Coastal Quarter SHD 2

Stage 1 Quality Audit

Shankill Property Investments Limited

Stage 1 Road Safety Audit

Figure 3-3 – Desire Line at Junction 12

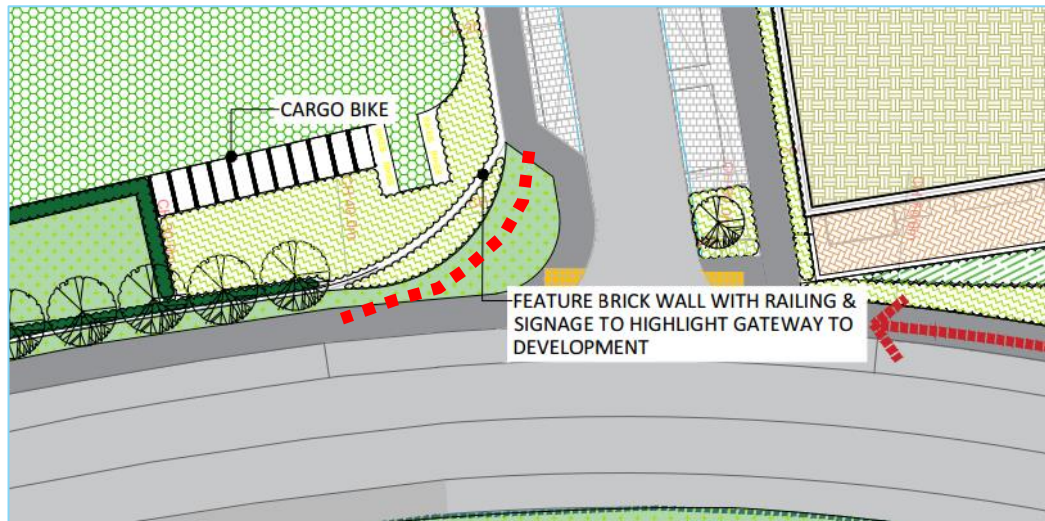
The landscape drawings do not appear to have catered for likely the pedestrian desire line pictured below in **Figure 3-3**. Footfall on this landscaped area could pose a risk to vulnerable users potentially leading to slipping, tripping or falling

The Designer should ensure that likely pedestrian desire lines are catered for at this location.

3.1.1	y	y	Tactile paving area as indicated to be removed.	
3.1.2	y	y	Tactile paving to be provided to facilitate crossing.	
3.1.3	n	n	The proposed footpath is positioned sufficiently close to the desire line.	Yes. The Designer has confirmed design proposals are adequate.

Figure 3-4 – Narrow Pedestrian Path

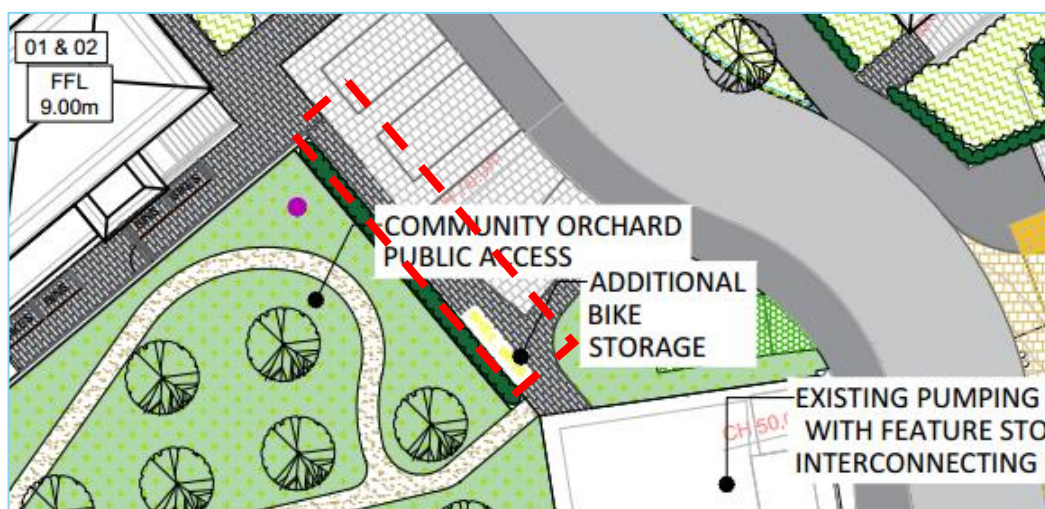
The landscape drawings detail a narrow pedestrian path to the rear of the parking bays as shown in **Figure 3-4** below. Lack of adequate width along the path may impede the movement of those less abled. Potential arises for personal injury to those in wheelchairs looking to use the facilities made available. The narrow width might result in vulnerable users pushed into the parked cars when facing oncoming footpath traffic.

The Designer should ensure that sufficient width is provided to vulnerable road users along the footpath.

3.1.4	y	n	The dedicated footpath along the route is positioned directly adjacent the street and is of sufficient width to cater for all users.	Yes. The Designer has confirmed design proposals are adequate.

Figure 3-5 – Informal Path on Approach to the School Entrance

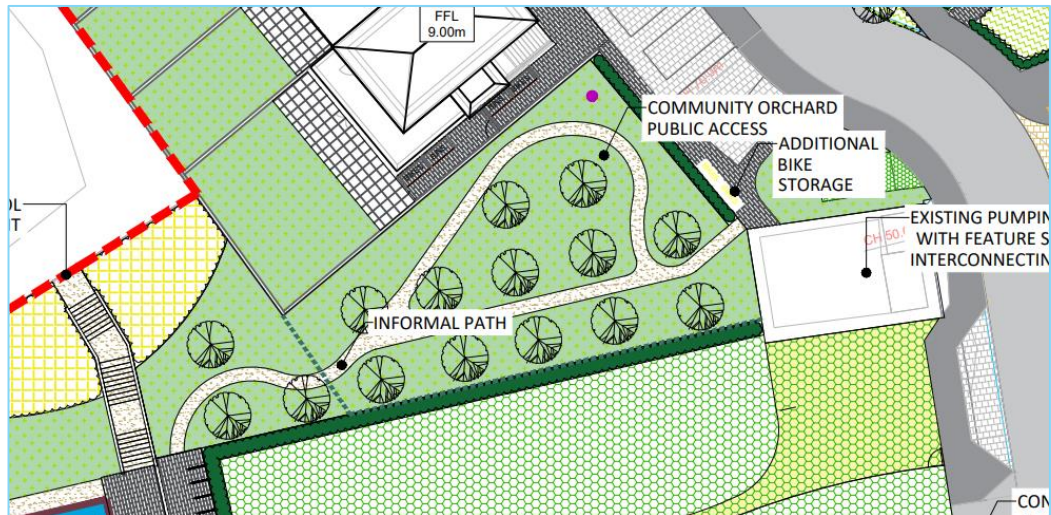
The landscape drawings detail a narrow informal path on approach to the school entrance steps as shown in **Figure 3-10** below. Lack of adequate width along the path may impede the movement of those less able. Potential arises for vulnerable user slips, trips and falls at this location.

The Designer should ensure the path is wide enough to cater for likely demand and user needs.

3.1.5	y	n	The community orchard is an informal space with limited access and any stepped connection with the school is subject to agreement. Width and material of paths to be developed at detail design stage	Yes. To be considered further at detailed design.

Figure 3-6 – Access for Wheelchair Users on Approach to School Entrance

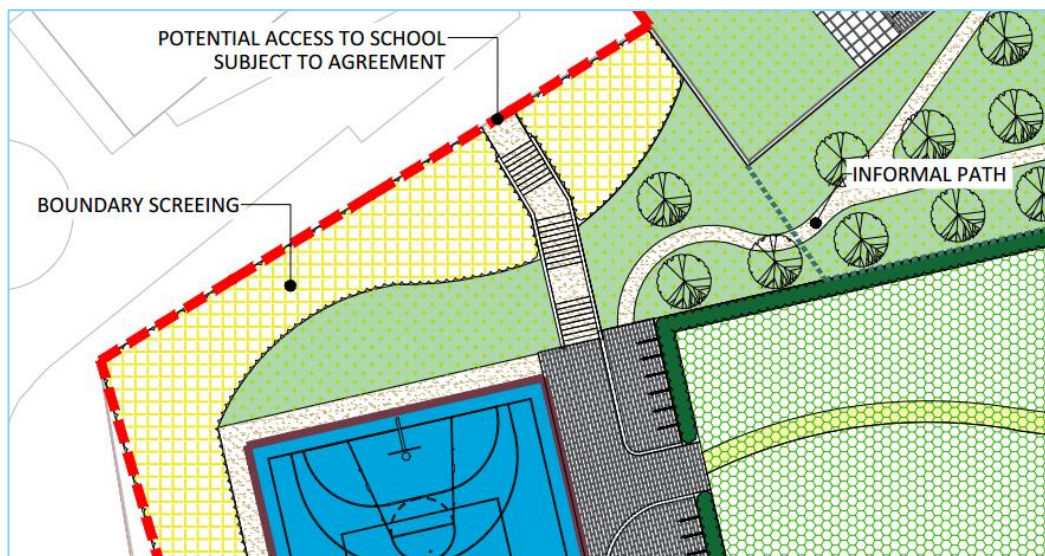
The landscape drawings appear to be missing adequate wheelchair friendly facilities as shown by the steps on approach to the boundary in **Figure 3-6** below. Lack of adequate wheelchair facilities can impede the movement of those less able.

The Designer should consider the provision of wheelchair friendly facilities.

3.1.6	y	n	Infrastructure for a compliant and designated less abled movement entrance has been provided by the school just outside the application red line boundary on the west corner of the site. Potential stepped access has been designed as a secondary linkage to the school and it is subject to agreement.	Yes. Provided for elsewhere. This connection is noted for later agreement.

Figure 3-7 – Pedestrian Crossing Facilities

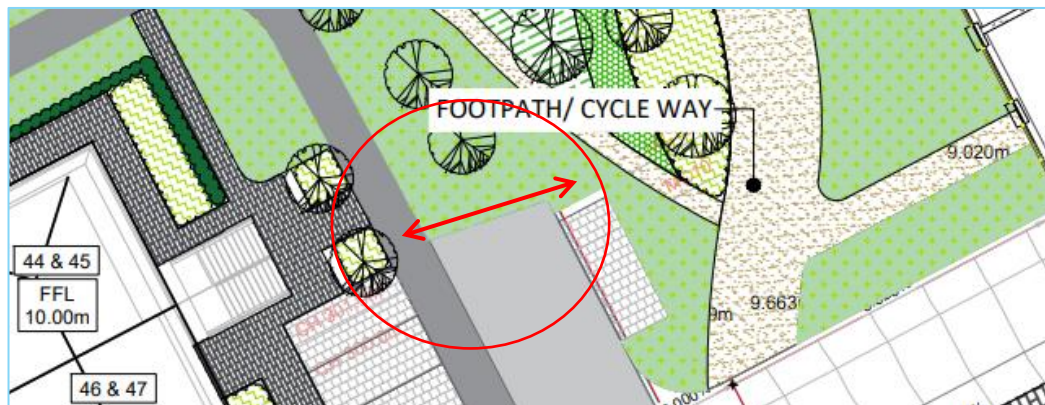
The landscape drawings appear to be missing adequate pedestrian crossing facilities to cater for pedestrian desire lines from the housing block to the adjacent park and greenspace. This may result in pedestrians entering the live carriageway or utilising a desire line in the grass as pictured in **Figure 3-7**.

The Designer should consider providing a pedestrian path along the head of the road connecting these houses to the nearby greenspace.

3.1.7	y	y	The pedestrian desire lines are catered for by the paths proposed as part of the landscape design.	Final materials, colours and textures to be examined at detailed design stage.

Figure 3-8 – Transition from Shared Space to Pedestrian Zone

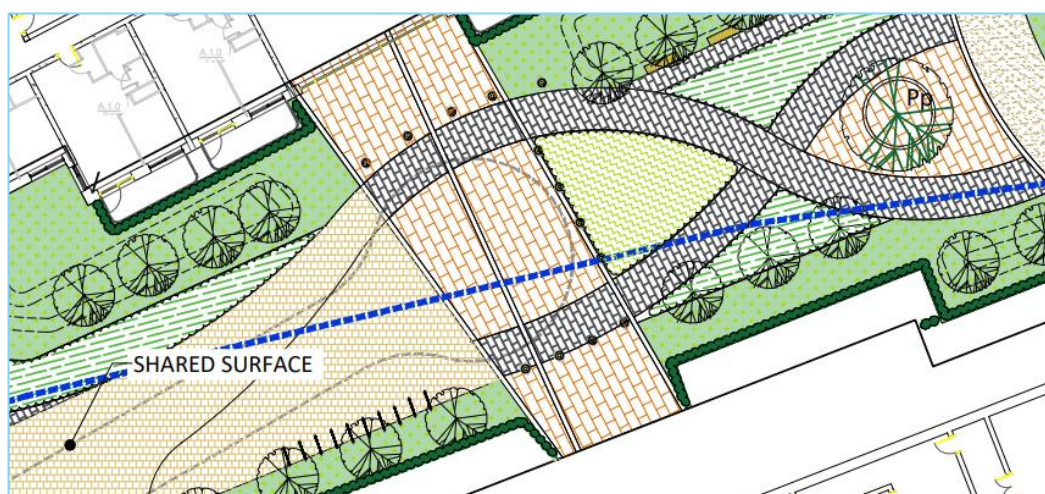
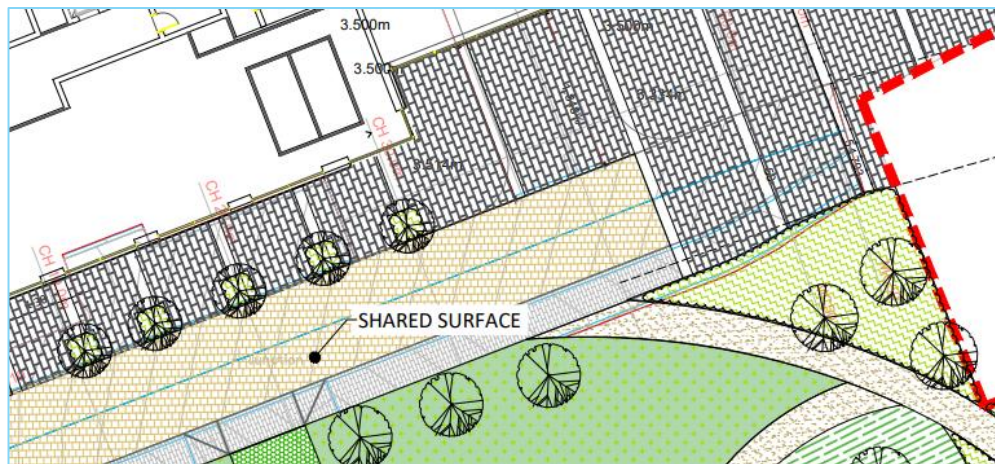
There is no tactile warning provided at the transition between pedestrian zone and shared space at the locations shown in **Figure 3-8** and **Figure 3-9** below. This may result in vulnerable and visually impaired pedestrians unknowingly entering the shared space. This may cause vehicle pedestrian conflicts.

The Designer should consider the provision of tactile tiles to mark the transition between pedestrian and shared zones.

3.1.8	y	y	 <p>Changing paving in colour and texture define vehicular and pedestrian route.</p>	
3.1.9	y	n	 <p>With the existing nature of the site the proposed road levels from east to west are critical. In order to provide level frontages to the GF units in Block C, the plaza area has had to be designed as a series of terraces. A compliant access route from east to west has been designed on the peripheral footpath around the plaza which then provides compliant linkage to each terrace level.</p>	Yes. Site constraints are noted that influence the design layout.
3.1.10	y	n	<p>The location and positioning of corduroy paving at steps will be developed at detailed design.</p>	Yes. To be considered further at detailed design.

Figure 3-10 – Access for Wheelchair Users

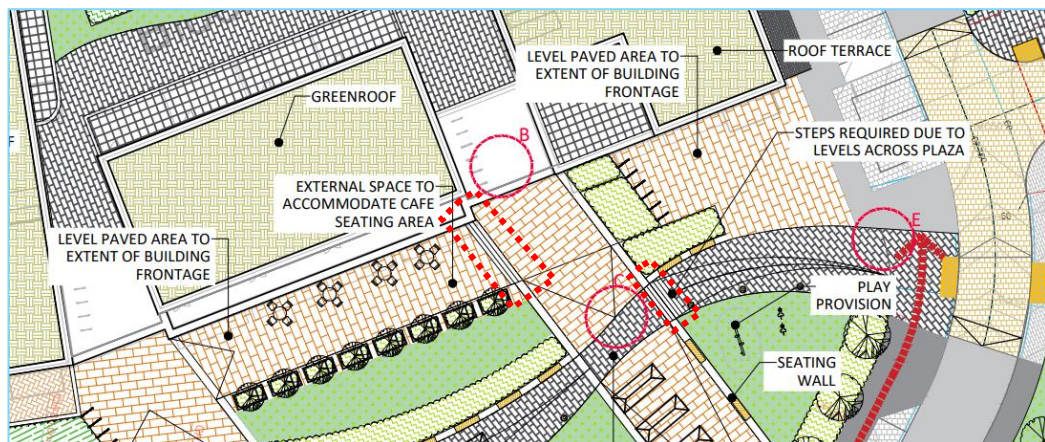
The landscape drawings appear to be missing adequate wheelchair friendly facilities as shown by the steps on approach to the boundary in **Figure-16** below. Lack of adequate wheelchair facilities can impede movement of those less abled.

The Designer should consider the provision of wheelchair friendly facilities in this area.

Figure 3-11 – Requirement for Corduroy Paving at Top and Bottom of Steps

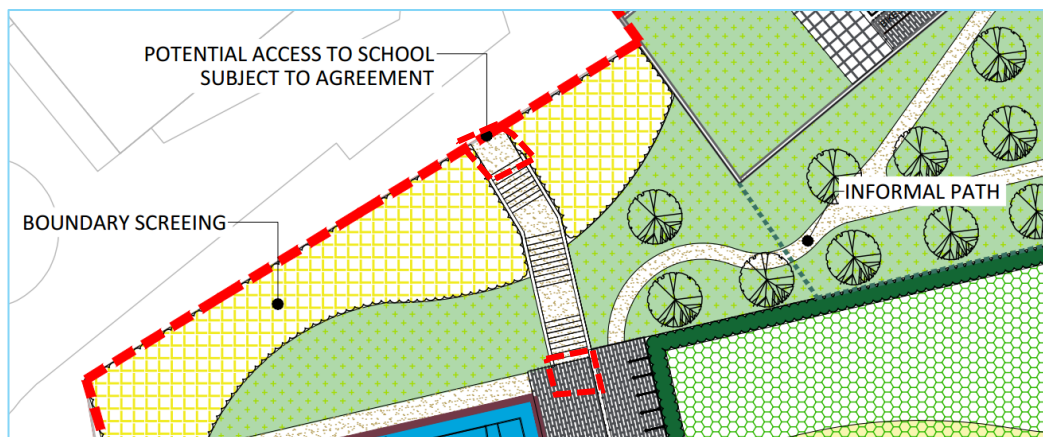
From the landscape drawings the provision of corduroy paving to the top and bottom of the steps throughout the scheme does not appear to have been made. Omission of corduroy paving may result in pedestrian slips, trips and falls which may result in injury type collisions.

Corduroy paving should be provided at the top and bottom of steps throughout the site in accordance with good practice.

Figure 3-12 – Plaza Layout

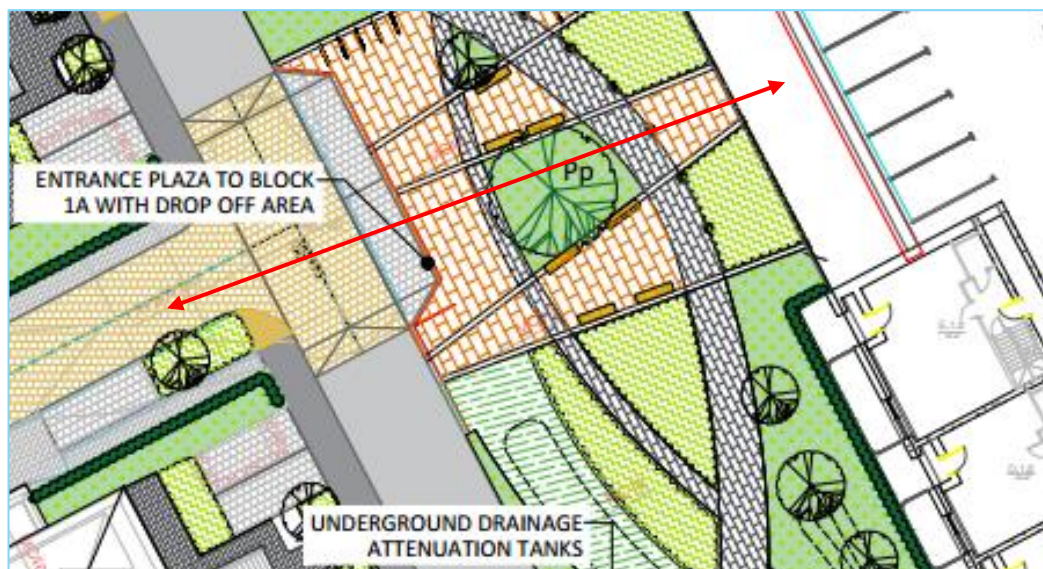
The landscape drawings show a large tree located in the centre of a key pedestrian desire line toward Block A. Planting at this location may compromise movement and lead to slips trips and falls and progression issues for less abled users.

The Designer should rationalise the tree planting at this location as part of the detailed design.

3.1.11	n	n	 <p>The main movement in this location is north to south. Access from drop off bay to podium is still available around the proposed planting bed and focal tree planting.</p>	<p>Yes. The Designer has confirmed design proposals are adequate.</p>
--------	---	---	---	---

Figure 2-1 – Junction 11

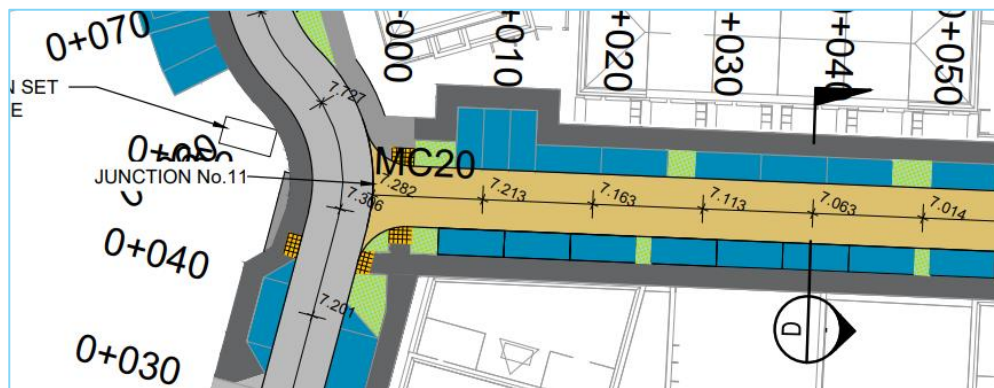
Larger vehicles to the east of Junction 11 may reverse onto the pedestrian crossing facilities as they look to manoeuvre out of the perpendicular parking bays. The presence of trees may exacerbate the issue. This may result in vehicles colliding with crossing pedestrians and may result in injury.

The designer should consider increasing the setback at this location to ensure large vehicles do not reverse onto the crossing point.

2.1	n	n	<p>The crossing will be repositioned away from the perpendicular bay as much as is possible, however as the screen grab to the left indicates a larger car can comfortably reverse out of the perpendicular parking back without intersecting the crossing area and as such the designer do not consider this to be a safety problem.</p> 	Yes. The Designer has confirmed the design is appropriate.

Figure 2-3 - Junction 4 & Junction 8

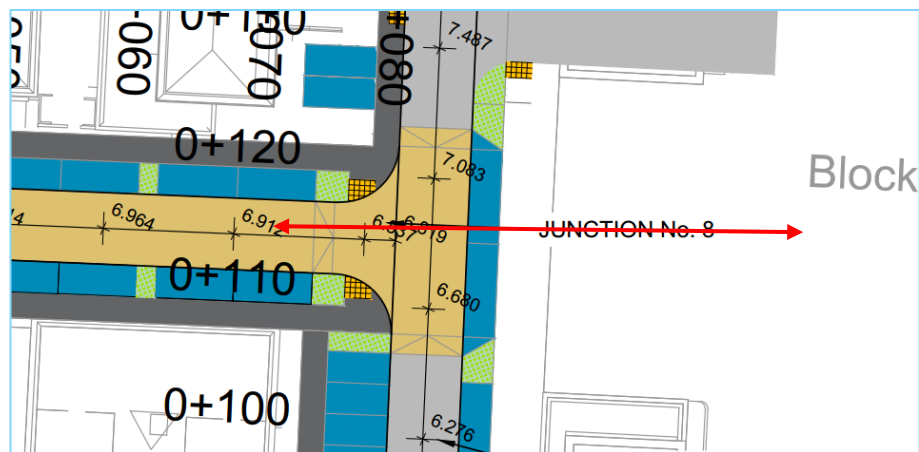
The design drawings indicate the presence of parallel parking bays along the east of Junction 4 and Junction 8 as shown in **Error! Reference source not found.** Figure 2-3 below. These arrangements will obstruct pedestrians looking to cross east/west at the junctions and likewise drivers being less able to see pedestrians crossing. This may result in pedestrians having to enter the roadway at undesignated locations which may result in pedestrian to vehicle collisions. These locations are the main entrance to point to the adjacent apartment blocks. It would likely people wishing to travel east-west and vice versa will wish to take this path and will be obstructed by the movement of parked or manoeuvring vehicles.

The Designer should ensure that pedestrian desire lines are catered for at these junction crossing points. Pedestrians desire lines should not be obstructed by vehicles.

2.2	y	y	A crossing will be facilitated in vicinity to the south of Junction 8 to accommodate this desire line. A crossing to the immediate north of Junction 4 is already provided.

Figure 2-5 – Visibility of Underground Car Park Entrance

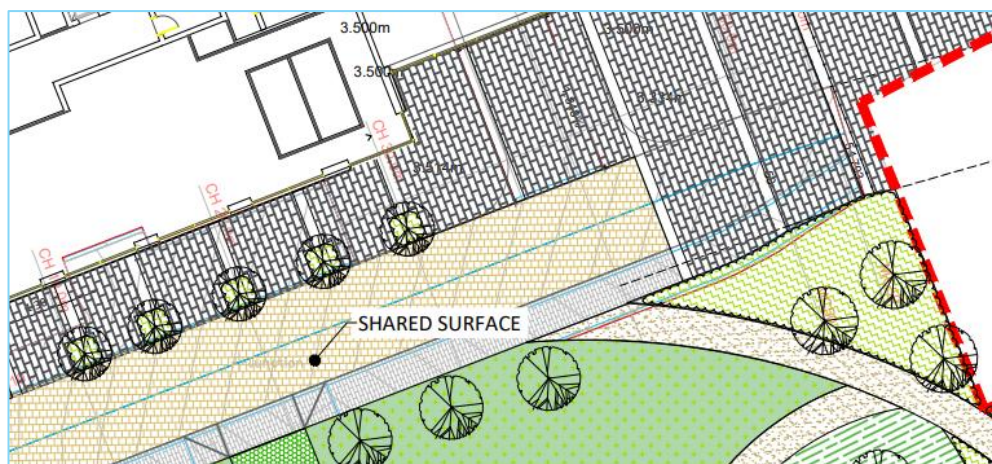
There is an entrance to an underground carpark at this location which is difficult to identify based on the surfacing materials chosen. The lack of pedestrian warning on approach may lead to vulnerable users slipping, tripping or falling into the junction and the risk of vehicle pedestrian conflicts.

The designer should consider how pedestrians are being warned on approach to the underground carpark entrance.

2.4	y	y	<p>To facilitate pedestrian movement, a designated crossing point has been provided, materials and surfacing have been addressed to provide separation and a clear delineation along with a traditional kerb line separation. Pavement material will be considered and specified at detailed design.</p>

Figure 2-4 – Surfacing and Lack of Crossing Facilities at Junction 6

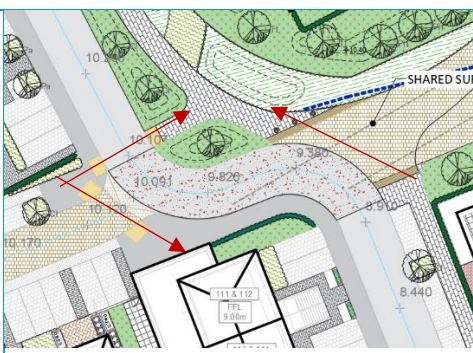
The landscape drawings detail an 'asphalt with red chip road' surface for the bend at Junction 6 of the scheme. This surface is not used elsewhere throughout the scheme and

it is unclear if it is intended that this is to be used similar to the adjoining shared path provision.

Junction 6 forms a key link for the east to west and north to south desire lines and may direct vulnerable users into an active carriageway where it is unsafe for them to enter. The transition from pedestrian zone to shared space appears unmarked/lacking delineation, leaving vulnerable and visually impaired pedestrians in danger of entering a live carriageway.

The layout should be reviewed and amended to address the risks highlighted. Appropriate measures should be provided to adequately guide / warn and delineate vehicles and non-motorised traffic in this area.

2.3	y	y	Junction 6 is a particular serpentine type of road that doesn't appear in any other location in the scheme. For this reason, a 'red chip road surface' has been designed to visually clearly distinguish pedestrian areas and vehicular areas over and above the kerblines that separate footpath from carriageway. To facilitate pedestrian movement, a designated crossing point has been provided.
